OIL SHALE TRACTS U-A AND U-B

Supplemental Material to the
WHITE RIVER SHALE PROJECT
DETAILED DEVELOPMENT PLAN

Compiled by
Oil Shale Office

January, 1982

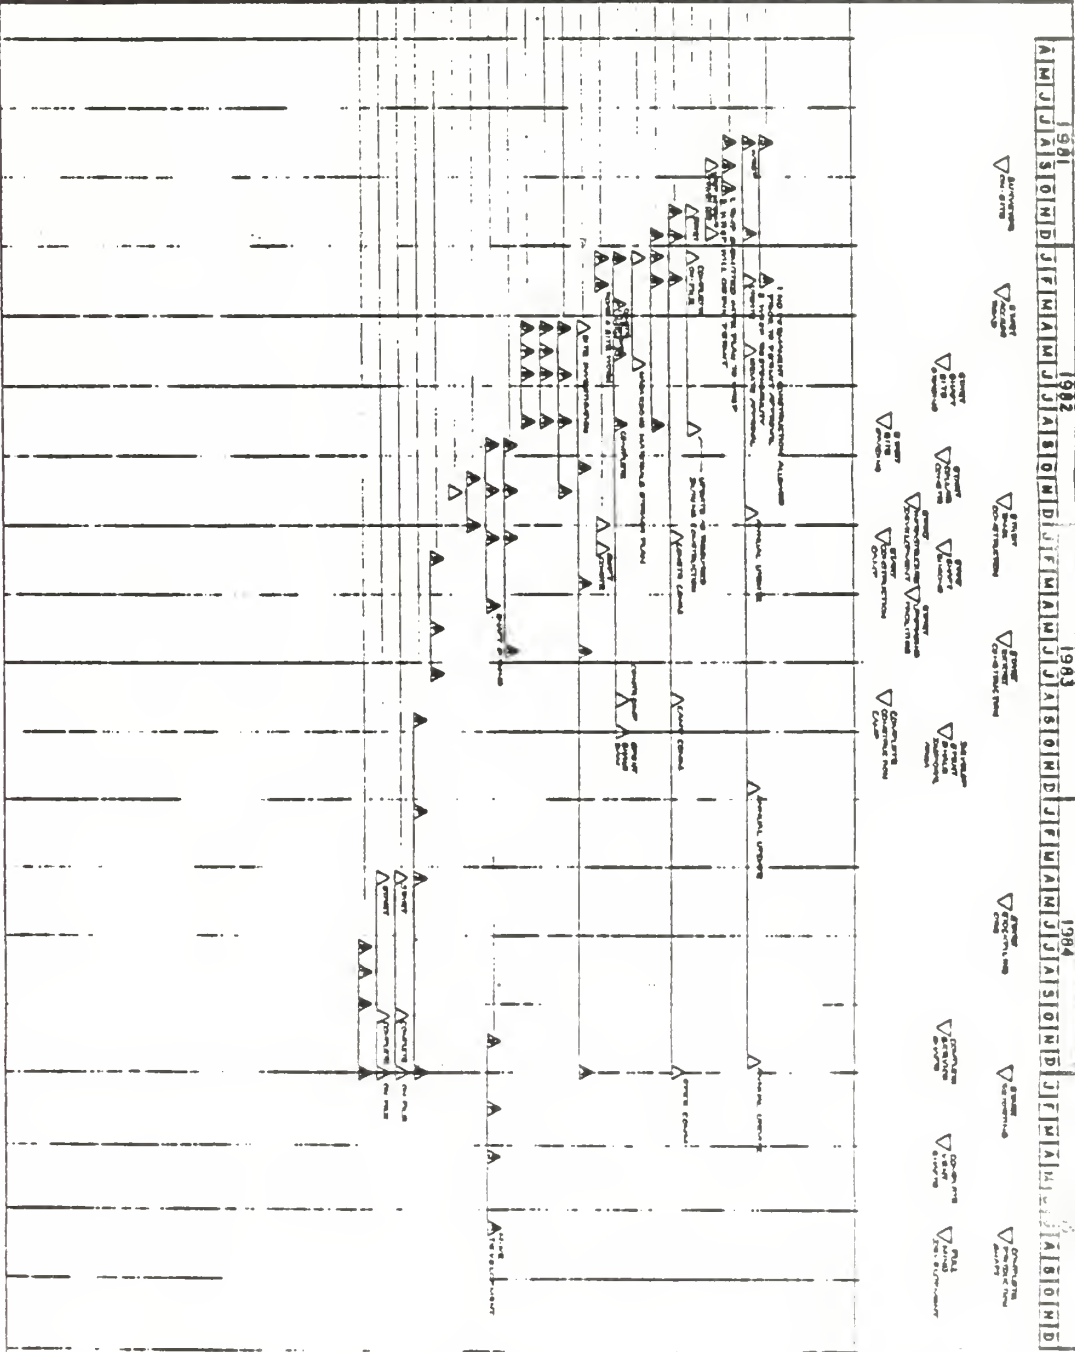
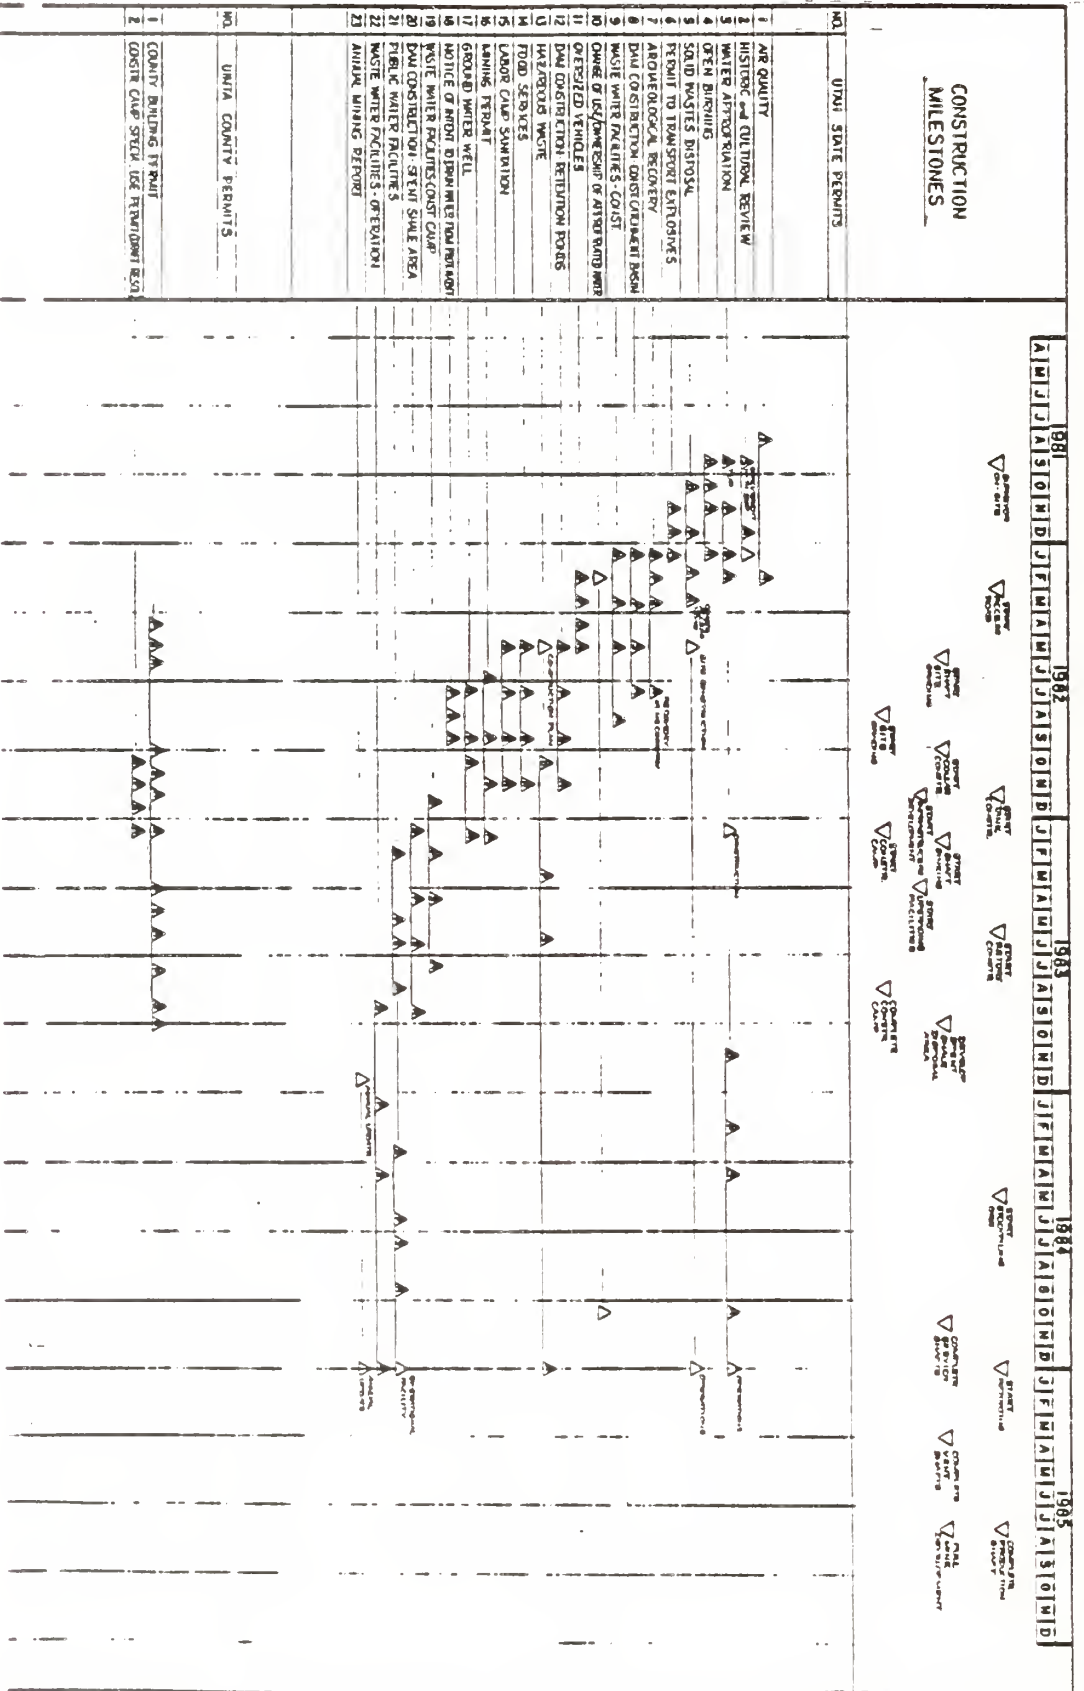
- 7) Submit a revised schedule with as much detail as possible in view of conflicts between Figure 3.3-2 in the DDP and permit schedule as attachment in the 10/20/81 supplemental material.

(7) Question: Submit a revised schedule with as much detail as possible in view of conflicts between Figure 3.3-2 in the DDP and permit schedule as attachment in the 10/20/81 supplemental material.

WRSOC RESPONSE NO. 1: Attachment No. 1 is the current permit schedule for the project. This schedule addresses only those generic permits needed for on-tract development. As the project schedule becomes more well-defined and as our off-tract development needs are identified, revisions to this permits schedule will be made. The OSO will receive updated schedules as they are prepared.

Answer: Revised Master Project Schedules are now being finalized for WRSP. Copies will be forwarded to OSO by December 23, 1981.

Figure 3.5-5 PANEL EXTRACTION SCHEDULE

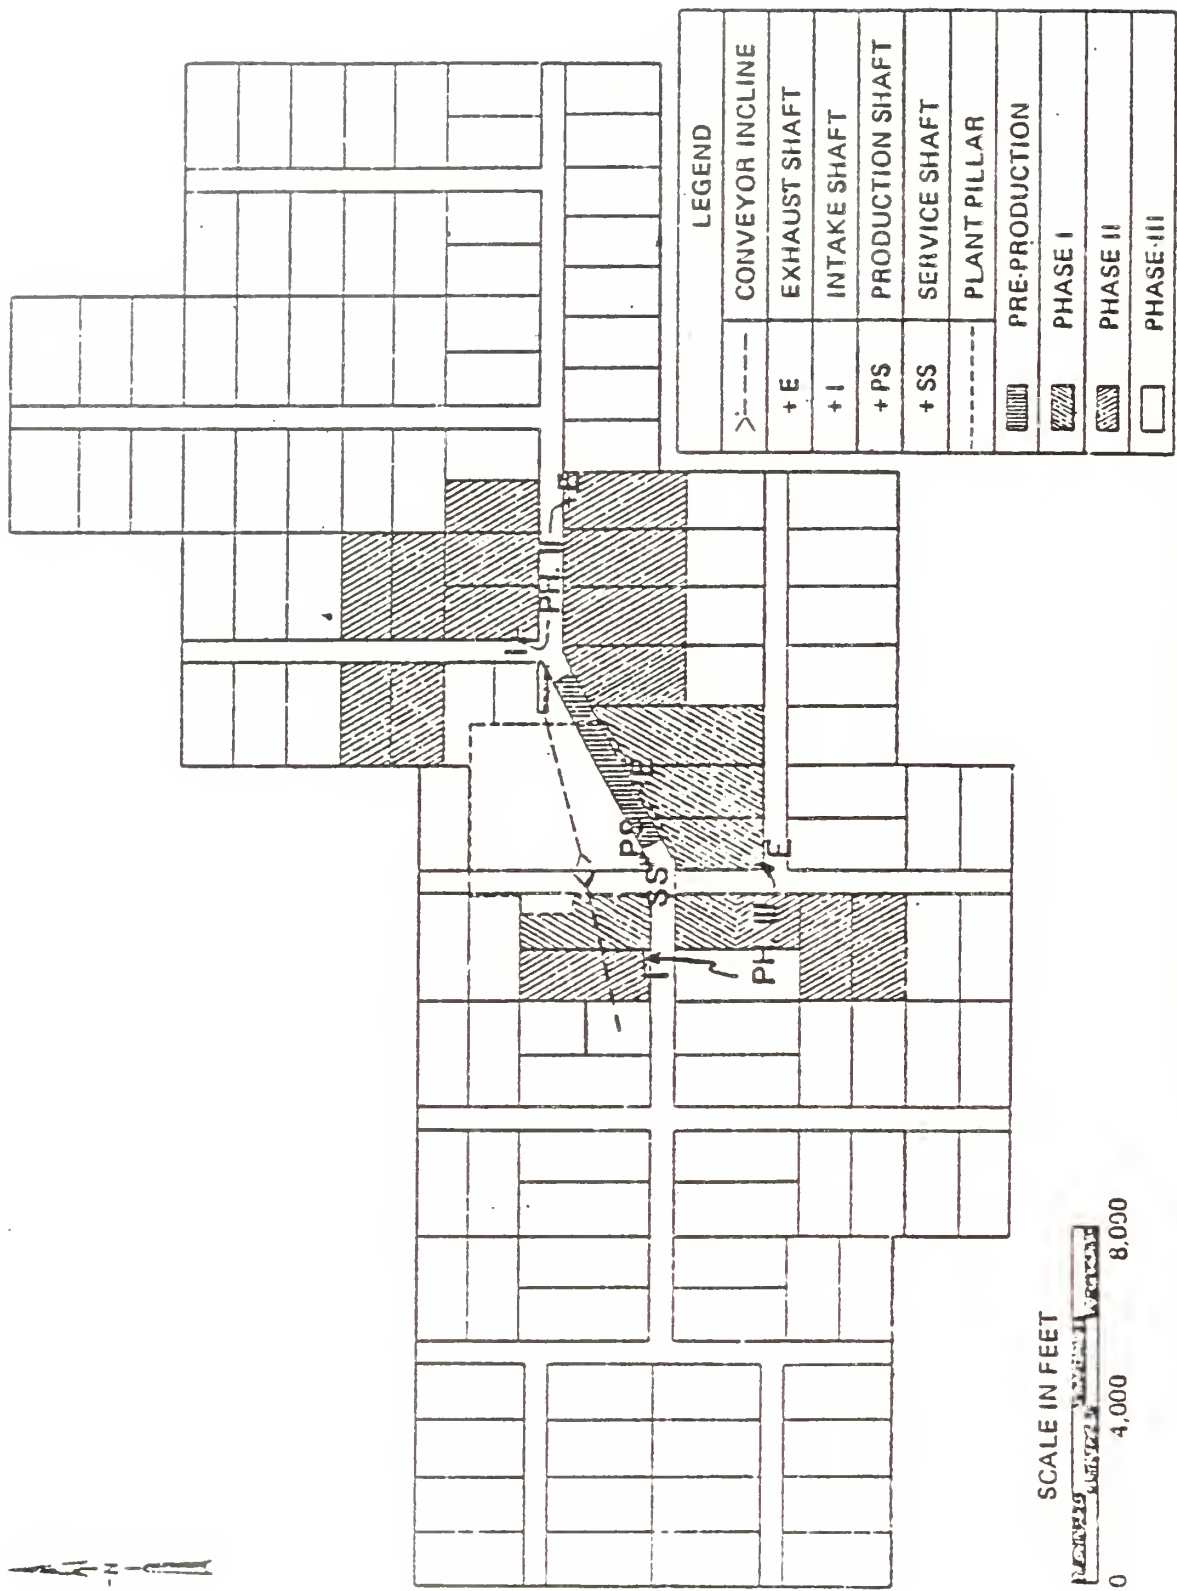
4. A revision to Figure 3.5-7 that shows the ventilation direction in the panels reversed in order to comply with gassy mine regulations. Figure 3.5-5 should be revised to show a pillar in the mined panels below the decline in the westerly direction.

OSO REQUEST NO. 4: A revision to Figure 3.5-7 showing the ventilation direction reversed. A revision to Figure 3.5-5 to show pillar in mined panels below westerly decline.

- 8) A pillar should be shown under the westerly decline on figure 3.5-5.
- 9) Phase I processed shale plan is not sufficiently detailed to evaluate the experimental design. Lessee needs to commit to submission for approval of the final detailed design prior to initial development of processed shale disposal area.

(8) Question: A pillar should be shown under the westerly decline on figure 3.5-5.

WRSOC RESPONSE NO. 4: WRSOC is continuing to review Figure 3.5-7 concerning ventilation direction in the mined panels. We will advise the OSO of our findings and decision in this matter shortly. Of course, the final design will fully comply with applicable mine safety regulations. Attachment No. 3 is Figure 3.5-5 revised, as requested.

Answer: In the WRSP supplemental material submitted to the OSO on October 20, 1981 a revised Figure 3.5-5 was provided showing a pillar beneath the toe of the westerly decline. It is our intention to properly support the decline.

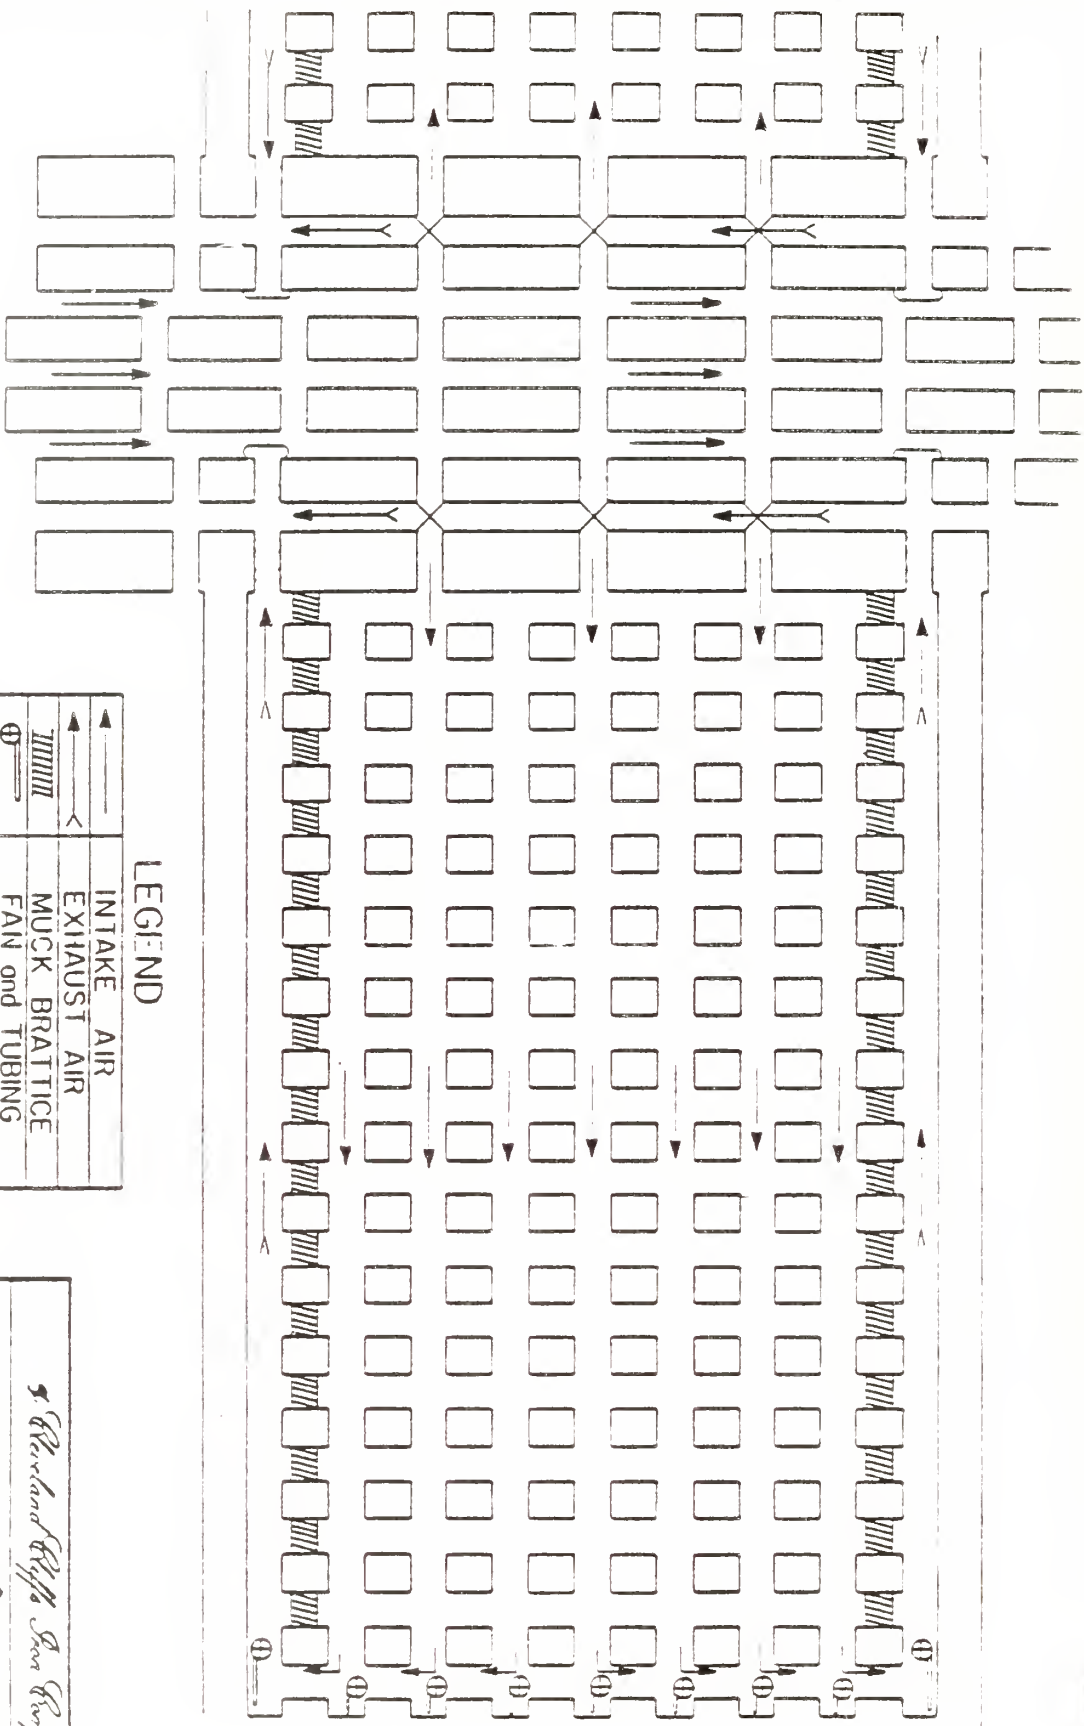
- 10) Should not the ventilation be reversed in figure 3.7-7? Provide a schematic for primary ventilation of Phases II & III.
- 11) Consideration should be given to disposal of fines from the dust collectors on the surface rather than underground to eliminate the possibility of spontaneous combustion in the mine.

(10) Question: Should not the ventilation be reversed in figure 3.5-7? Provide a schematic for primary ventilation of Phases II and III.

Answer: Attachment No. 2 is a revised copy of Figure 3.5-7 showing our typical mine panel ventilation plan. White River is proceeding with a detailed ventilation study for all three phases of the project. The first portion of the study should be completed in January, 1982 and it will be reviewed with the OSO at that time.
